November 2, 1973

SUBJECT: FUEL DENSIFICATION

Enclosed are new γ -curves for Maximum Average Planar Linear Heat Generation Rate. The enclosed figures replace the similarly numbered figures in NEDM 10735 Supplement 6, 7, and 8 composite. The enclosed figures are marked (Rev 11-5) to differentiate them from those which are presently in NEDM 10735. Curves 3-9A2, 4-9B1-4, and 4-9C2 were also checked and it was determined that no changes to those curves are necessary.

Figure 4-9A1 Maximum Allowable Average Planar LHGR Applicable to Fuel Type Reload 1 (Rev. 11-5)

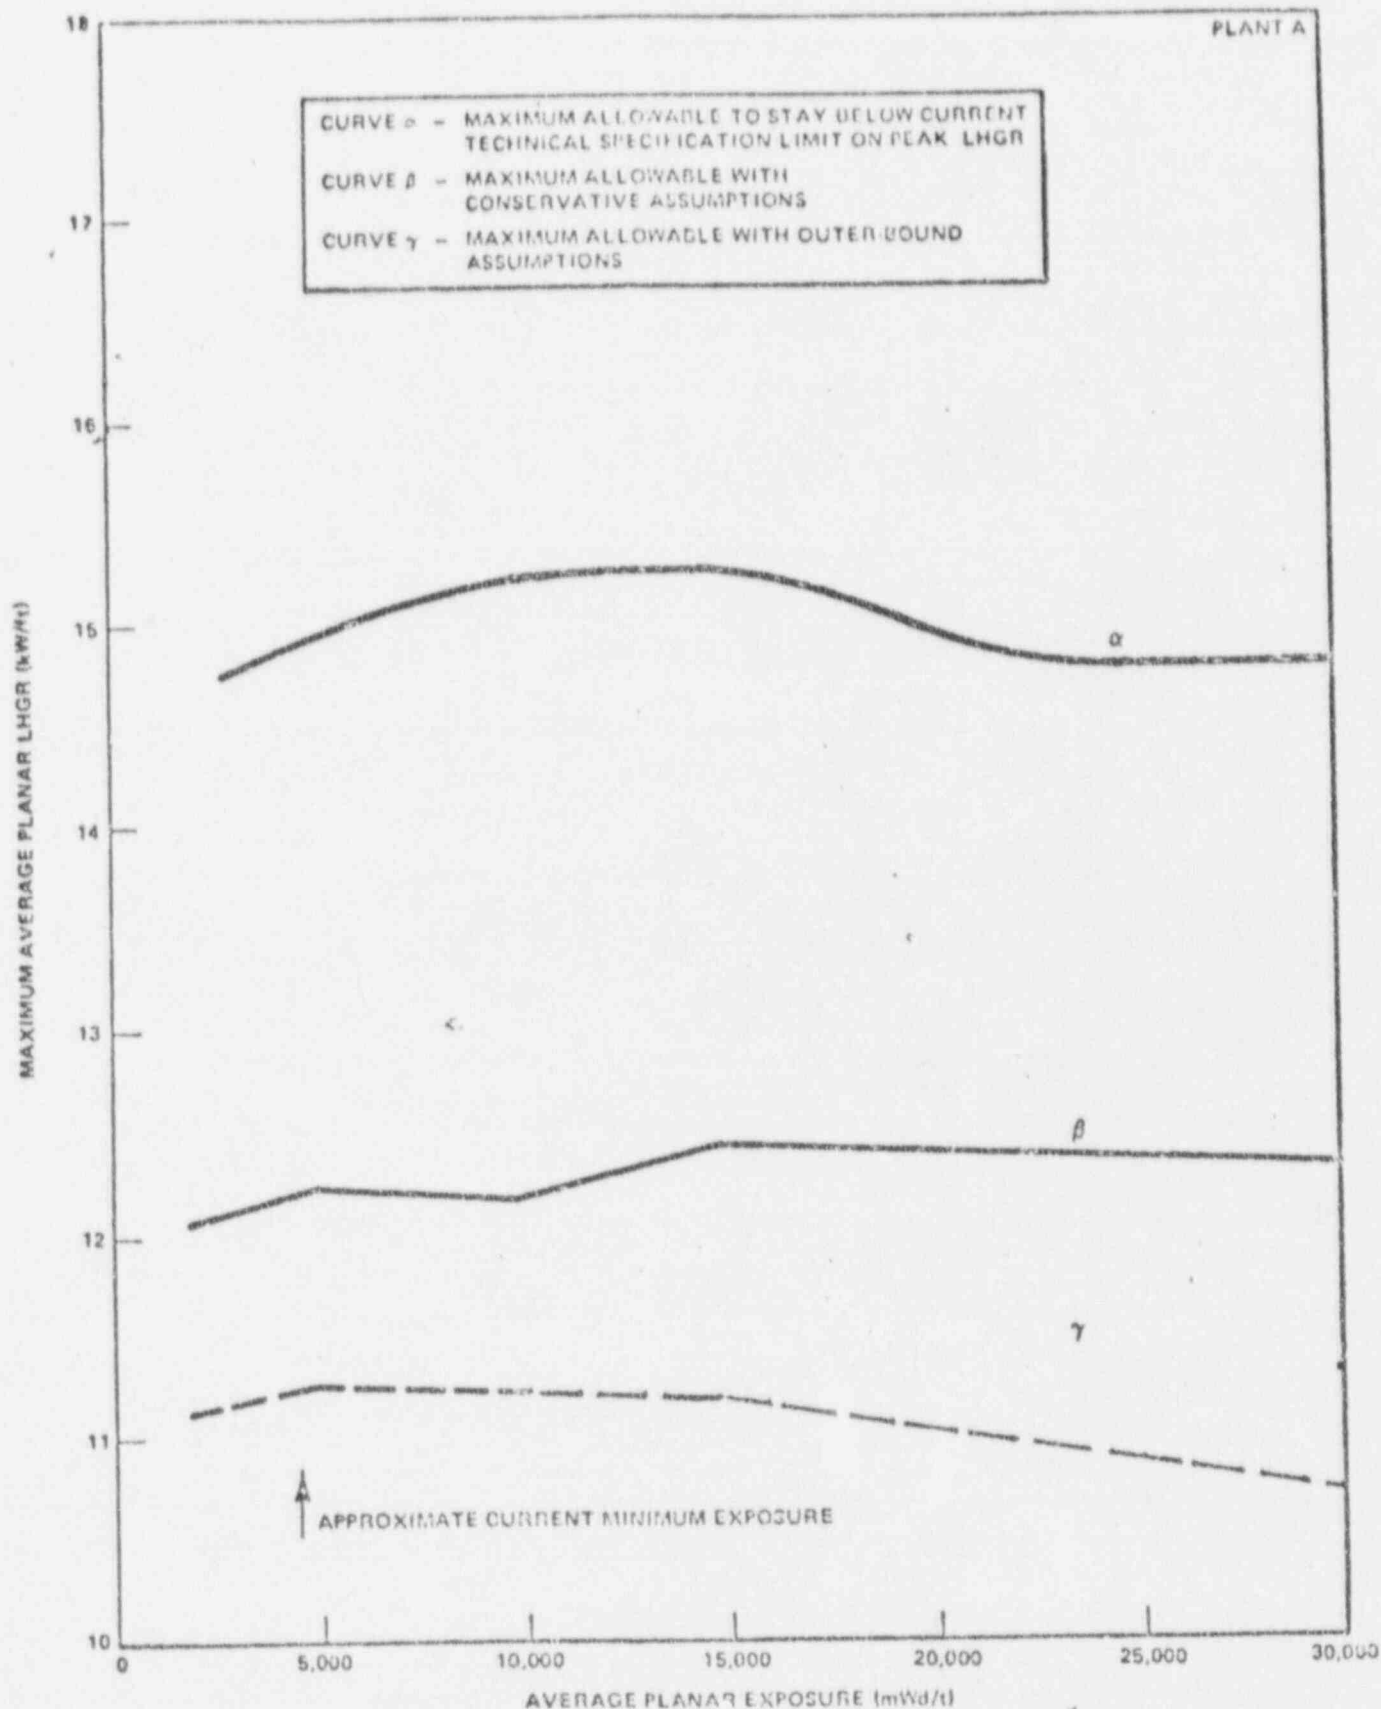
As requested in the referenced telecon, these curves have computer calculated points for 25,000 MWD/T exposure.
